## ALERT SERVICE BULLETIN NO. ASB315-63/2

G 103 TWIN II	S/N 3501 – 3729
	S/N 3730 – 3878
	S/N 33879 – 34078
G 103A TWIN II ACRO	S/N 3544 – 34078 (mit Suffix „K“)
G 103C TWIN III ACRO	S/N 34101 – 34203

Limitation of Operation

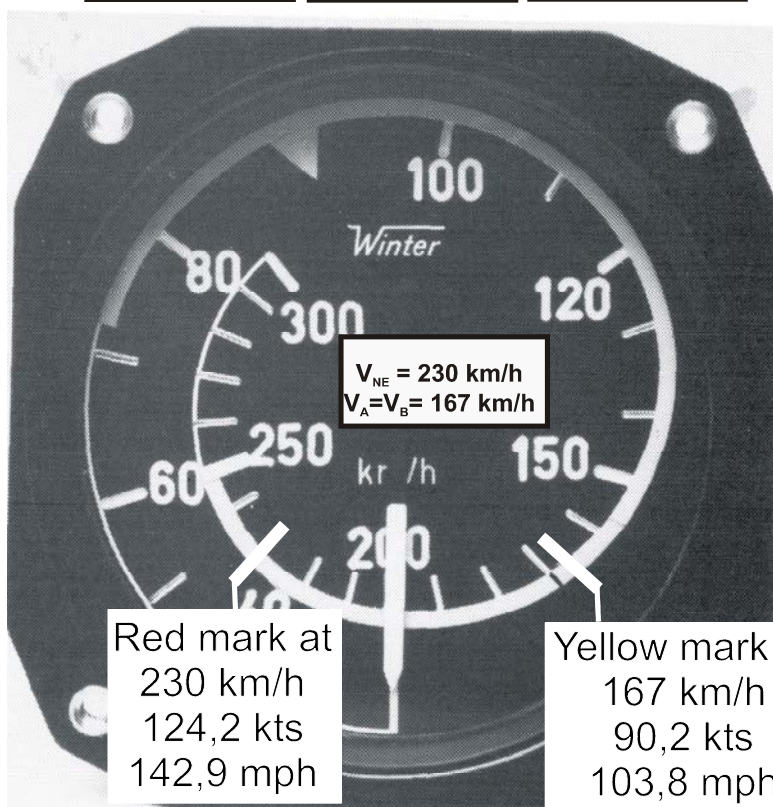
- 1.8.1 Apply on the front and rear airspeed indicator
- a red mark at **230 km/h (124,2 kts, / 142,9 mph)**
  - a yellow mark at **167 km/h (90,2 kts, / 103,8 mph)**

NOTE: The marks are attached to the SB.
